Department of Planning and Zoning

MEMORANDUM

To: The Design Advisory Board
From: Mary O'Neil, AICP, Senior Planner
RE: ZP 14-0499CA/MA; 237 North Winooski Avenue
Date: November 26, 2013

File: ZP 14-0499CA/MA
Location: 237 North Winooski Avenue
Zone: NMU Ward: 2
Date application accepted: October 23, 2013
Applicant/ Owner: Hot Eats, Cool Treats LLC (Redstone) / Kathy Goguen
Estimated Construction Cost: \$3,000,000
Request: Demolish former Dairy Queen / currently "Q-Tee-s" restaurant, redevelop site with a single building of 28 residential units and approx. 1,500 sf commercial space. Parking is proposed to be on grade located under the building in an open garage.

sheet no.
A2.1

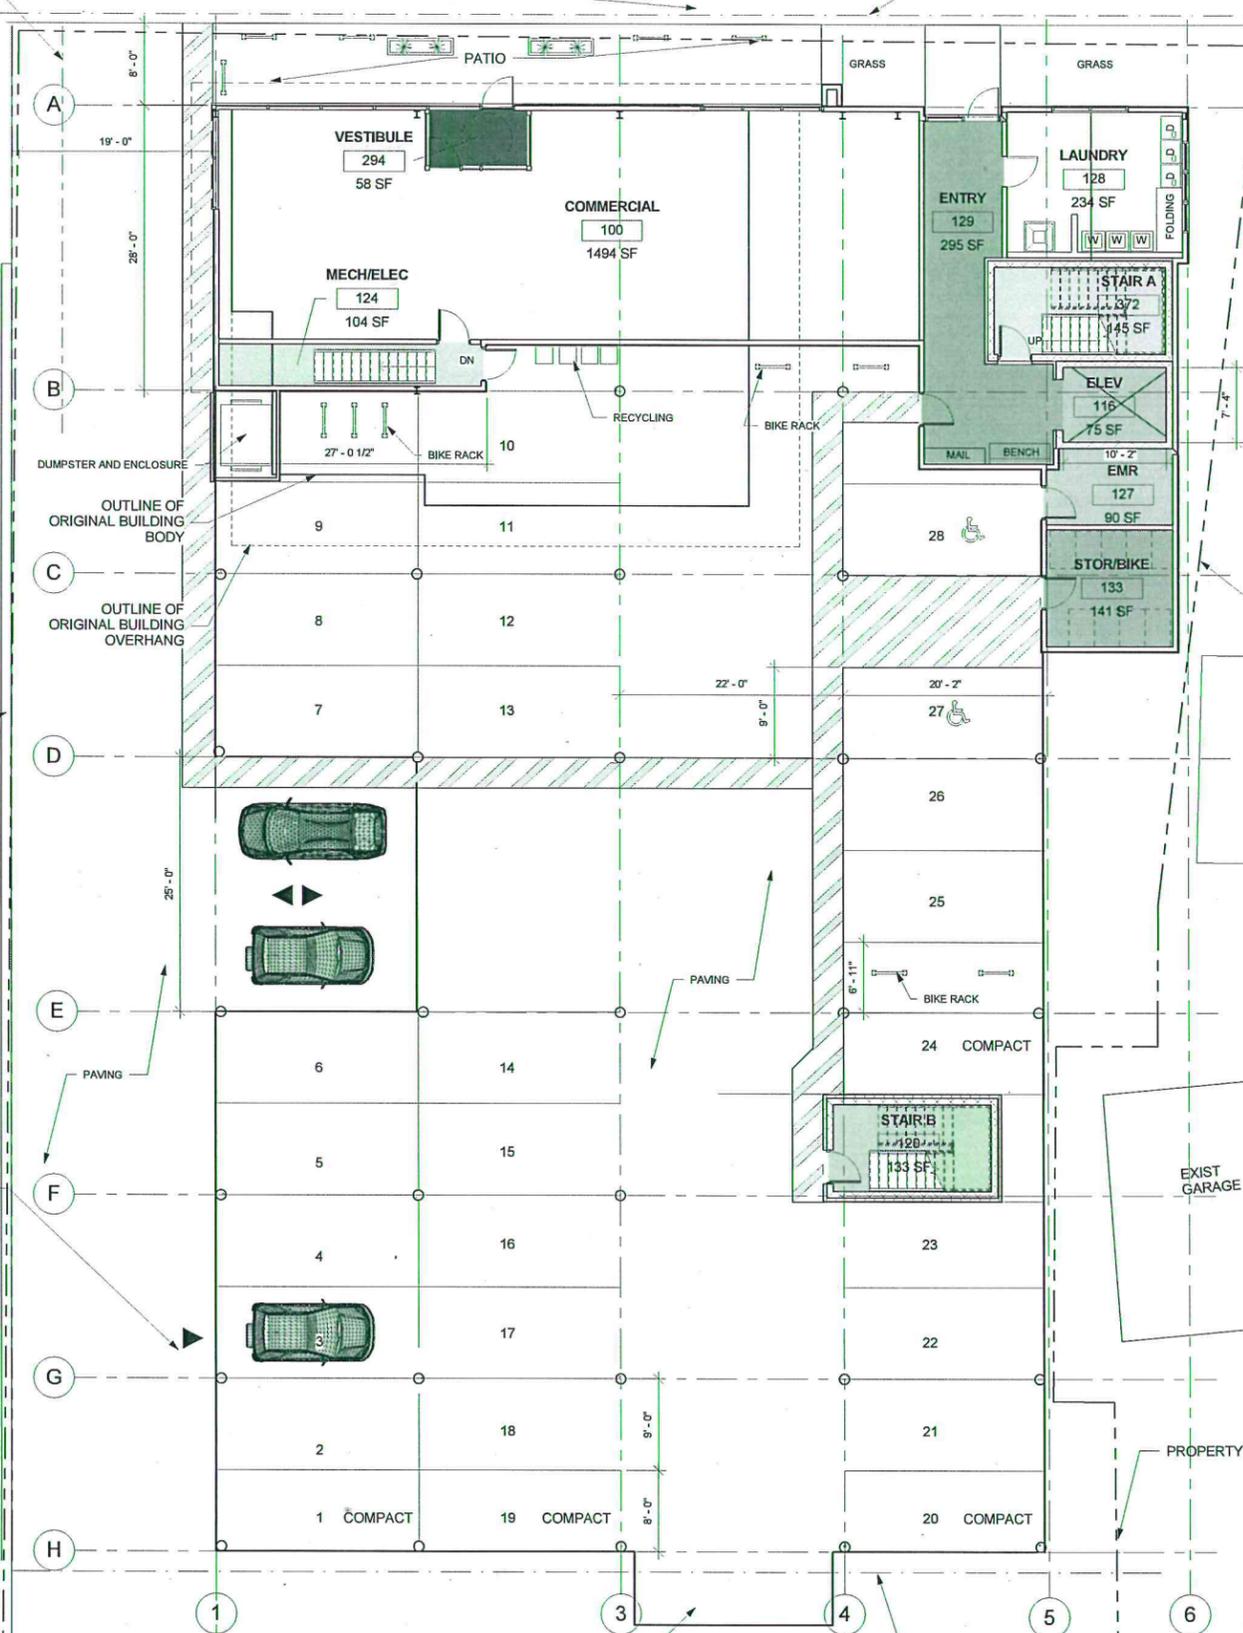
The parking access is provided via a double wide two-way lane; entering mid-structure at grade. From plan A2.1, easterly exterior parking spaces will be accessed by pulling-through from the entrance lane, rather than “stacked” from the interior. This “pull-through” access for exterior parking spaces may cause some confusion for the central access point, as exiting drivers will not anticipate vehicles moving in front of them. The arrangement appears to present additional vulnerability to the support columns for the structure as cars will be driving around/through them from both sides

On examination, a car accessing the garage “entrance” will not likely be able to pull into spot 14 (or maybe even 13 or 15) without a multi-point turn, as the radius would be too tight. Although the plan meets the ordinance required 20’ aisle width, it does NOT meet the required 24’ (standard vehicle) or 20’ (compact vehicle) backup space on any of the interior or exterior parking spaces. (See **Table 8.1.11-1 Minimum Parking Dimensions.**)

Only 15% of parking may be considered for “compact” parking. 15% of 28 spaces = 4 spaces. Spaces 1, 19, 20 and 24 have been defined as compact parking spaces in the revised plan. The applicant needs to confirm the dimensions of all remaining parking spaces, to assure agreement with the ordinance.

The existing basement (from Q-Tees) is proposed as a mechanical/electrical area. (Plan A2.1.) If utility connections will be visible on the exterior of the structure, they need to be noted on elevations and/or site plans as appropriate.

sheet no.
A4.1

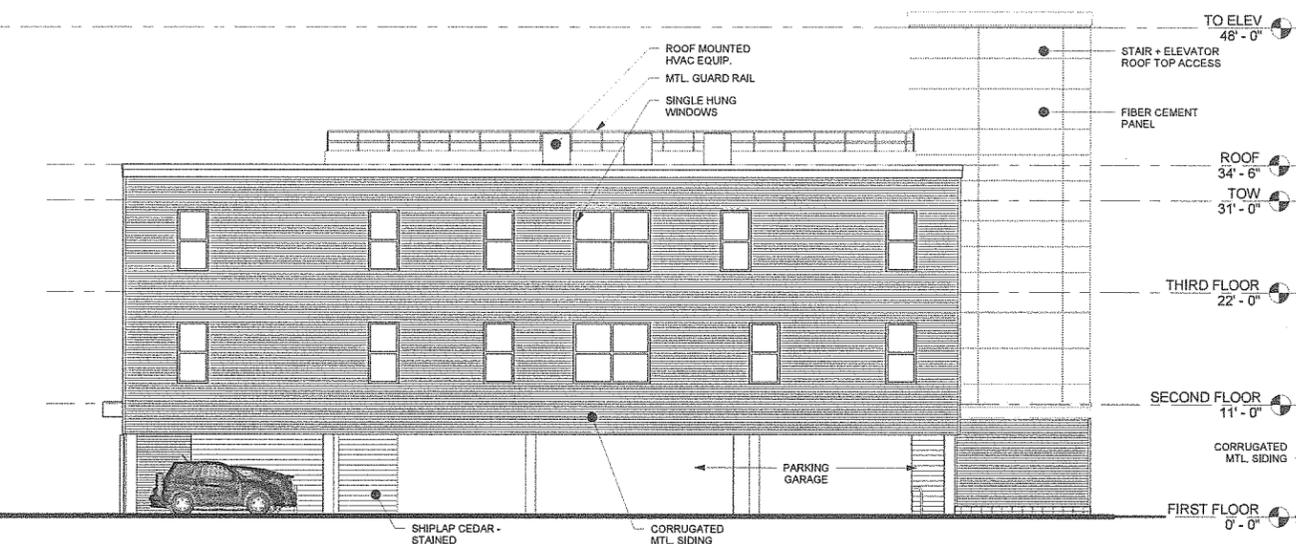
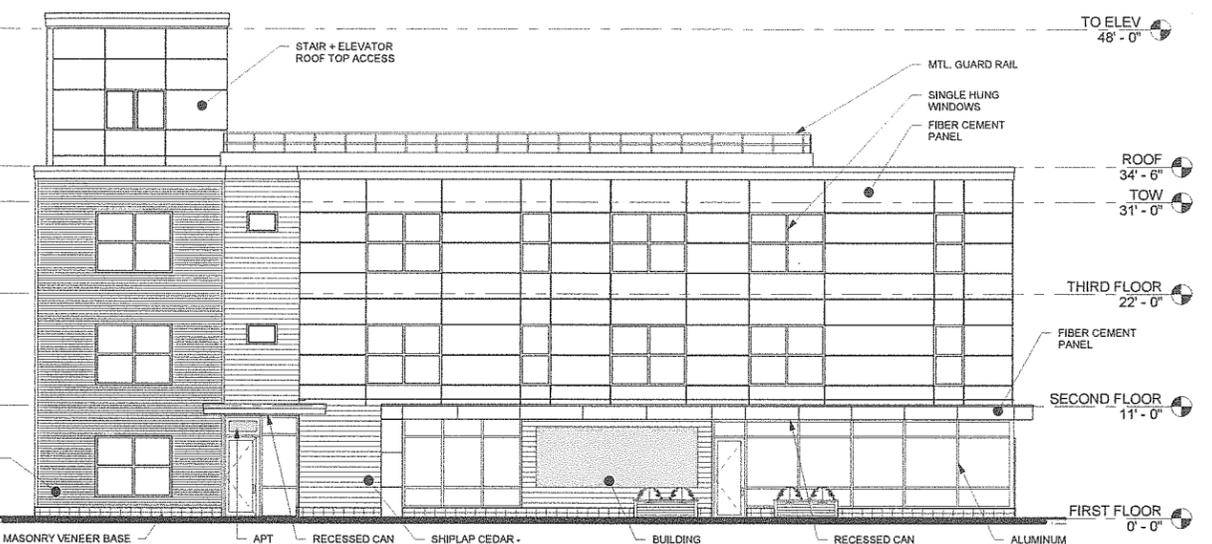
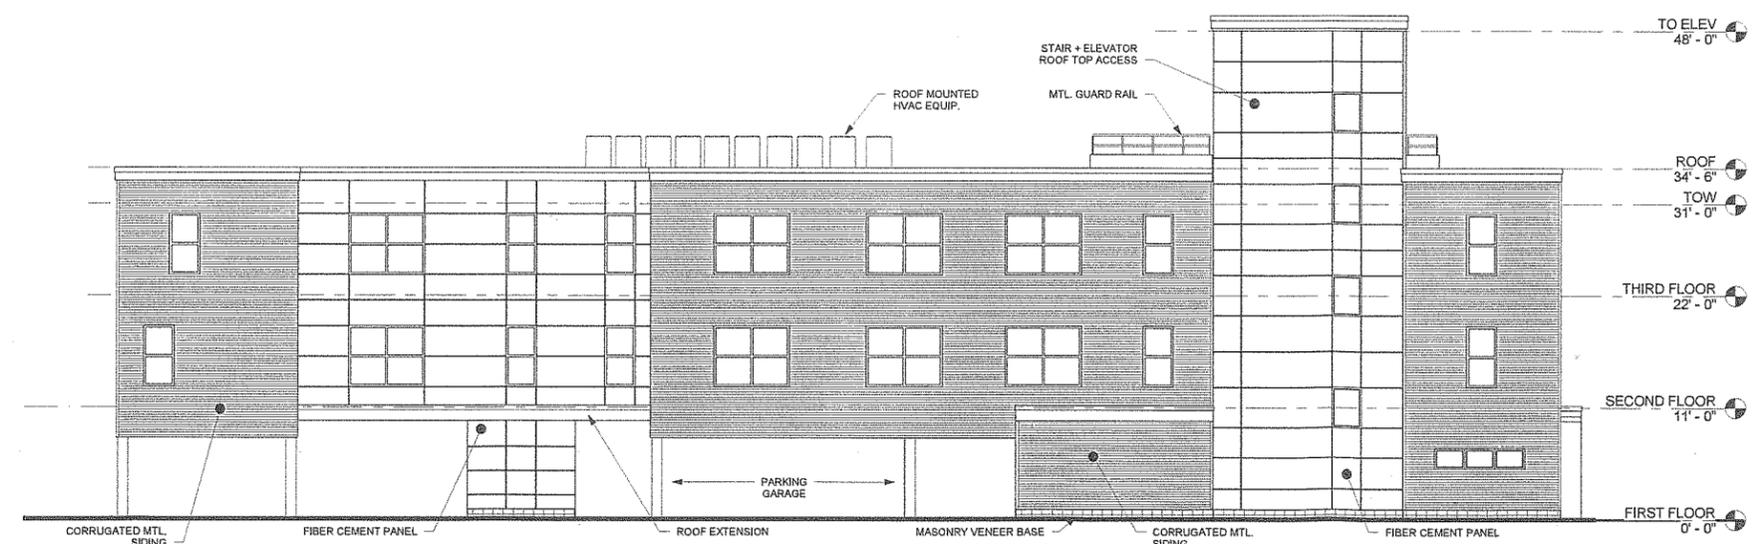
This standard requires any construction within 5' of a property line to be without windows or doors. The site plan does not illustrate a building setback along the rear westerly portion of the structure (where is it abutting a property line. It is not clear from the west elevation if there is a proposed "notch" as asserted by the applicant. The site plan may be showing the concrete pad outline, and not the structural outline, however. Plan A2.2 suggests the appropriate structural setback. The applicant shall confirm this alteration to meet the above standard.

1. added a notch in the south elevation of the building to meet the 5 foot window setback
2. eliminated external dumpster pad in lieu of internal dumpster storage as close to the driveway entrance as possible.

DATE: SEP. 4, 2013
SCALE: 1" = 10'
PRJ. NO.: 13203
DRAWING NUMBER: **C1.1**

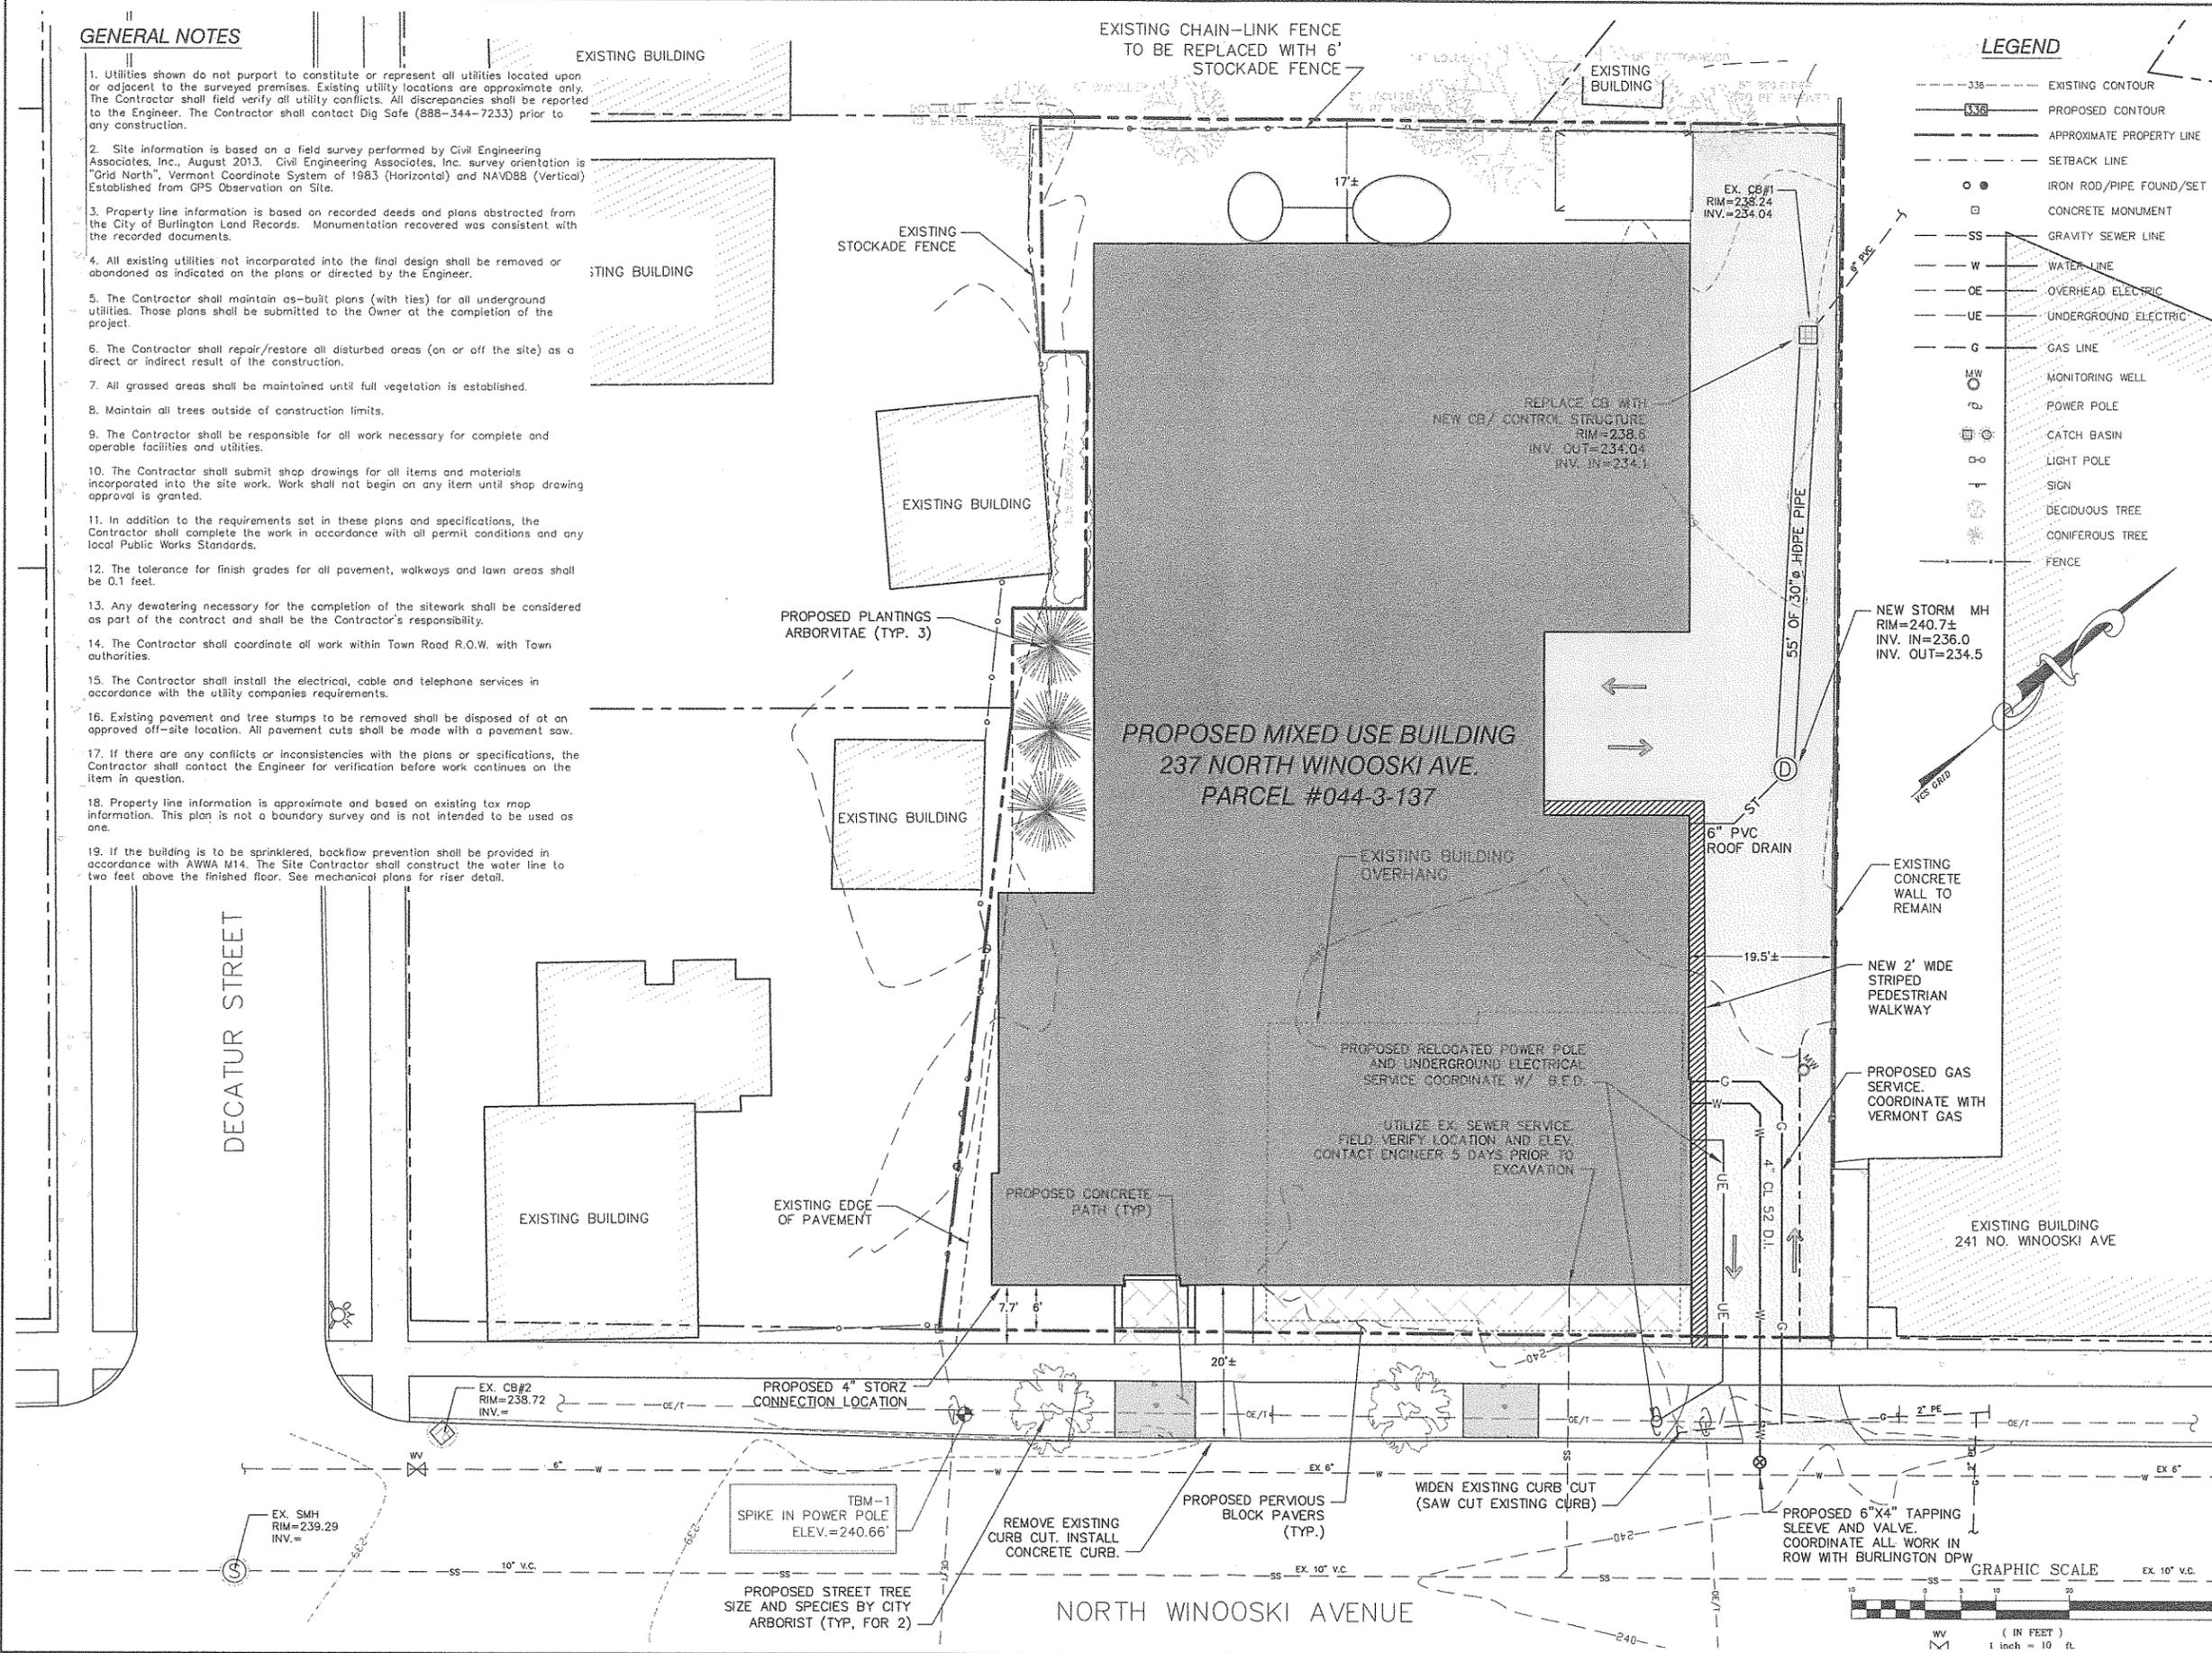
Plan C1.1 does not illustrate any significant changes to the topography of the site. Anticipated grading to provide a flat terrain for the slab is reflected in plan C1.2.

Footnote 4 in Table 4.4.2-1 requires a 12' setback from the curb. Measurements provided on the revised Plan C1.1 inform of the 20' +/- distance from the curb; meeting the standard.

Plan C1.1 defines the elimination of an existing curb cut at the west, and widening the existing curb cut on the east. DPW traffic engineering staff requested a traffic brief verifying site distances and estimating traffic generated by site versus traffic from current use. It was suggested at that time that some further analysis may be appropriate. Sight lines for vehicles exiting the driveway also need to be considered.
